DECLARATION – CASE NO RO0002892

Re: SLIC Case No. RO0002892, Chevron Sunol Pipeline, 2793 Calaveras Road, Sunol, CA

On behalf of Chevron Pipe Line Company (CPL), URS Corporation (URS) has prepared this letter in response to the ACEH comment letter to CPL dated March 14, 2006. In the letter, ACEH requested the Soil Vapor Extraction (SVE) system be expanded to include additional new SVE wells downslope from the release location. URS has explored various options to accommodate ACEH's request and has concluded that due to technical difficulties and serious safety concerns, it is not feasible to install one or more new SVE wells on the hillside downslope from the release location. Instead, based on the excellent SVE system performance to date and the site conditions, URS proposes to operate the SVE system for additional six months and also to cover the hillside with plastic in efforts to increase the radius of influence of each SVE well.

Photo 1 Installation of the straw wattles with 10-ft spacing on the hillslope and 20-ft spacing on the dirt road, December 7, 2005.

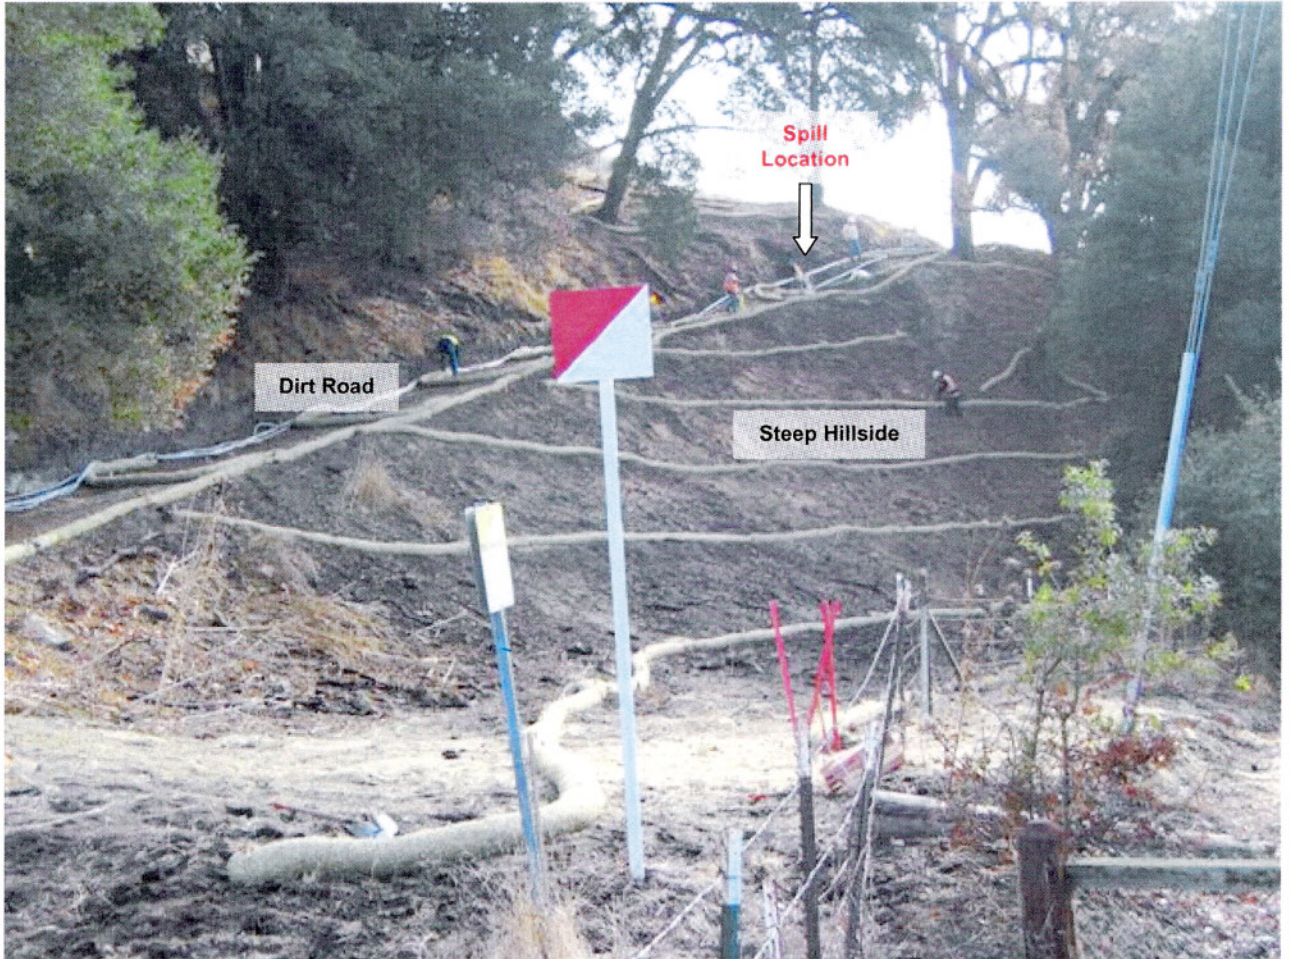
In the ACEH comment letter to CPL dated March 14, 2006, ACEH requested the SVE system be expanded to include SVE wells downslope from the release location. URS acknowledges that the ideal location for additional SVE wells would be in the area surrounding boring CP-SB-19 because the highest petroleum hydrocarbon concentrations were detected at this location.

URS has explored the feasibility of installing additional SVE well(s) near boring CB-SB-19. The limiting factor for installing SVE wells at the recommended locations is the very steep hillside. Photo 1 was taken during the revegetation effort. Straw wattles were installed for erosion control. The photo showed the pipeline release location, the dirt road, and the steep hillside. Photos 2 and 3 show the steep 84-percent slope immediately below the pipeline release location. The location of boring CP-SB-19 is also shown on both photos. The steepness of the hillside hinders the employment of a Geoprobe™ rig; therefore, borings CP-SB-15 through CP-SB-19 were hand augered. The field crew used a shovel to create temporary “steps” and conducted hand augering on the hillside. Even with the temporary steps, the hill slope was very slippery and URS ended CP-SB-19 at 2.5 feet below ground surface due to unsafe conditions. Based on the experience from hand augering borings at this location, URS has researched alternative drilling methods to install SVE wells on the hillside.

In summary, URS does not recommend installing additional SVE wells/trench on the hillside due to the technical difficulties and safety concerns.
